<p style="text-align: center;">CDM: Form for submission of requests for revisions of approved methodologies to the Methodologies Panel (version 01) (To be used by project participants, through the DOE/AE, for requesting revisions of approved methodologies)</p>	
Name of the entity (DOE) submitting this form	-
Reference number and title of the approved methodologies	AM0001 – Incineration of HFC23 waste streams
Title/Subject (give a short title or specify the subject of your submission, maximum 200 characters):	Revision to AM0001 to ensure that recent agreements under the Montreal Protocol do not create perverse incentives to produce HCFC-22 beyond levels that would occur in the absence of the project activity
Attach proposed revised approved methodology (with revisions in track change mode):	<input checked="" type="checkbox"/> Yes, is attached.
Attach draft CDM-PDD example of project activity:	<input type="checkbox"/> Yes, is attached.

Detailed explanation of the revision request

Implications of the new agreement under the Montreal Protocol

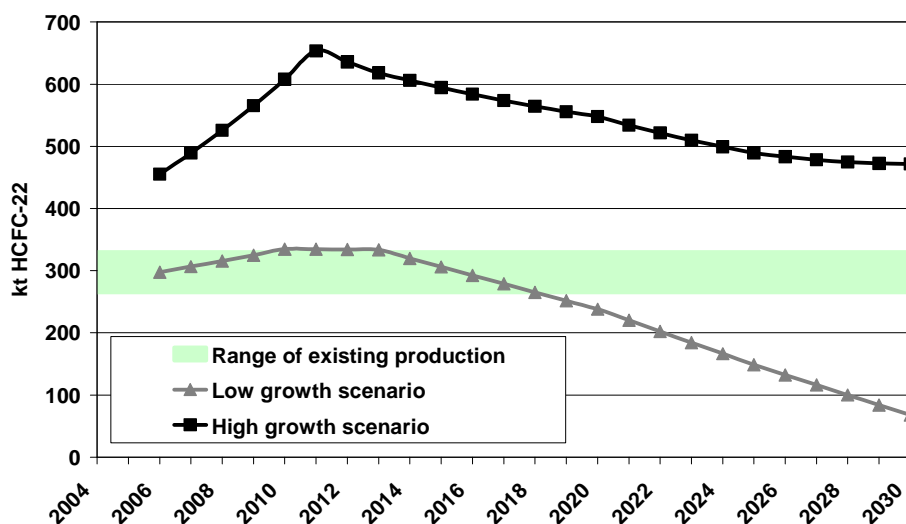
Prior to the new agreement under the Montreal Protocol, the growth of HCFC-22 production for emissive uses has been estimated in the literature (TEAP 2007, page 25) with a factor between 1.78 and 2.81 for the period 2005-2015, corresponding to an annual growth rate between 6% and 11%. Emissions have grown rapidly in the past due to various factors, including high economic growth in China and production shifts from Annex I to non-Annex I countries. With the new agreement under the Montreal Protocol, these growth rates are expected to slow down and can continue only for a limited time frame. Parties to the Montreal Protocol may start early to implement policies and measures to facilitate the implementation of the earlier phase out. To achieve stabilization by 2013 on the 2009/2010 level, HCFC-22 demand for emissive uses is likely to peak in about 2011. In addition, production shifts from Annex I to non-Annex I countries have already occurred to a large extent and the accelerated phase-out in Annex I countries may free up production capacities that can supply growing demand in developing countries.

These two scenarios are illustrated in the following figure. The figure shows the following: in the case of the high demand scenario, the demand for HCFC-22 in developing countries will always exceed the quantity of HCFC-22 that is eligible for crediting. In contrast, in the low demand scenario, the demand drops well below the quantity of HCFC-22 that is eligible for crediting.

As soon as the HCFC-22 demand drops below the quantity of HCFC-22 that is eligible for crediting, the current cap in AM0001 does not fulfil anymore its function of avoiding perverse incentives: operators would have strong economic incentives to continue HCFC-22 production even if the market demand drops. Data from UNFCCC (2005), the TEAP (2007) and other publications (Schneider et al. 2005) suggest that the economic incentives are considerable. The TEAP (2007, page 57) concludes that “the net revenue per year for HFC-23 destruction could easily exceed the revenue from HCFC-22 sales”. Schneider et al. (2005) have estimated the impact of CER revenues on HCFC-22 production costs for a range of possible assumptions (see figure below). In a “high impact” scenario, the revenues from CERs exceed the HCFC-22 production costs by a factor of 4-5. In the worst case, this could result in that HCFC-22 is produced which is not consumed but released to the atmosphere. In other cases, it could delay or exacerbate the achievements of the accelerated phase-out of HCFCs under the Montreal Protocol, with severe consequences for emissions of both greenhouse gases and ozone depleting substances.

Source: TEAP (2007, page 6)

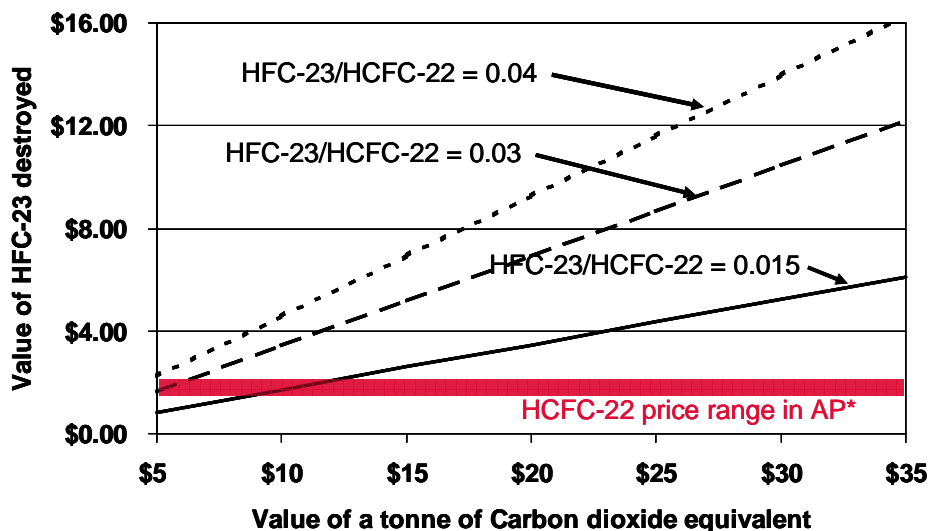
Similar conclusions have been confirmed by the TEAP. The figure below (TEAP 2007, page 6) illustrates the relation of CER revenues to HCFC-22 production costs for different CER prices and HFC-23/HCFC-22 ratios. The figure illustrates that CER revenues can easily exceed HCFC-22 production costs.
